*Request for Class II Permissive Change*

**FCC ID: VG8XM044KYY**

1. Changed mother board as below.

Original Mother board -bottom

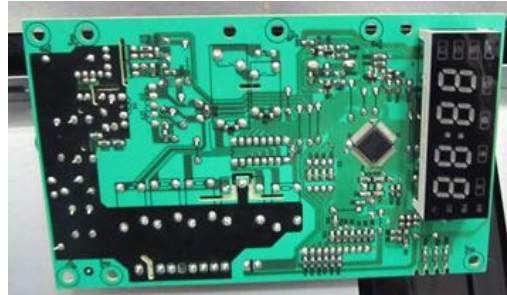
1. Difference to PCB Layout.
2. Anything else is the same as before.
